# PROJECT NAME: North West Cambridge Masterplan

## SCHEDULE OF APPLICANT'S RESPONSES TO COMMENTS RECEIVED

<b>COMMENTS RECEIVED FROM:</b> Environment Agency (EA)	<b>FORMAT:</b> Email	<b>DATE RECEIVED:</b> 30/10/2025
<b>SUBJECT:</b> Flood Risk and Surface Water Drainage

<b>COMMENTS RECEIVED FROM:</b>	Environment Agency (EA)	<b>FORMAT:</b>	Email	<b>DATE RECEIVED:</b>	13/02/2026
<b>SUBJECT:</b>	Flood Risk Technical Comments

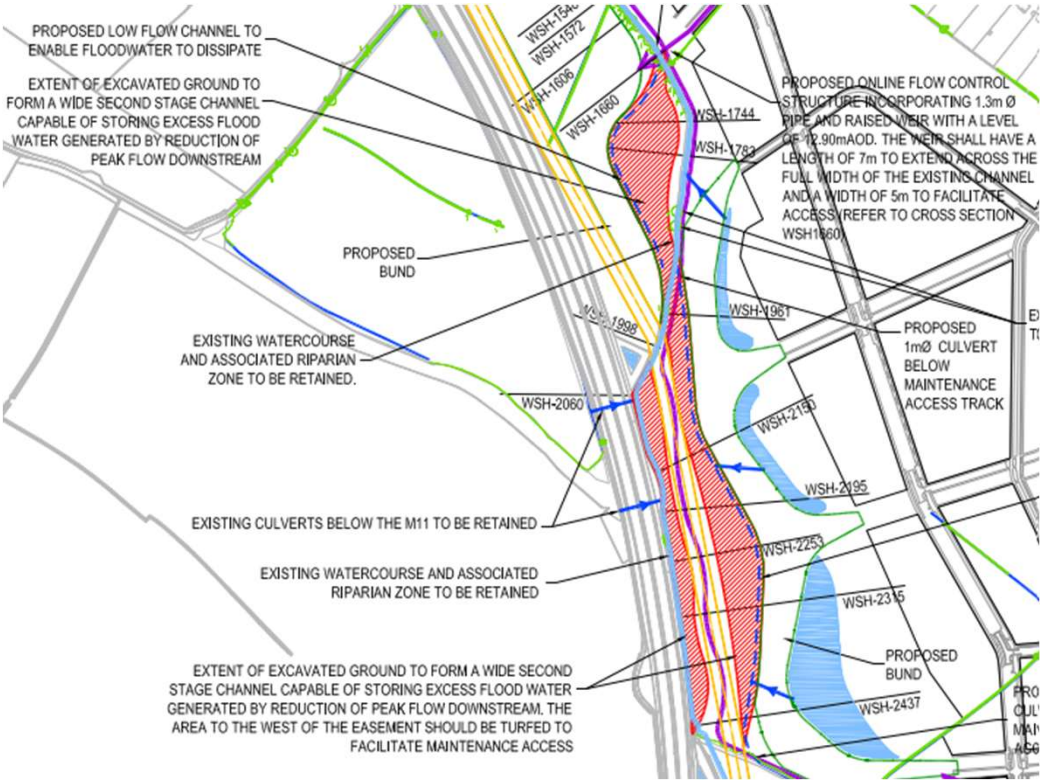
- Localized stockpiles of arisings within the site
- Need for reuse of the existing stockpiled arisings within the site and avoid offsite disposal
- Raised plot levels to facilitate reuse of arisings and limit excavation within the site.
- No land raising or built development within the latest Flood Zone 3 extent.
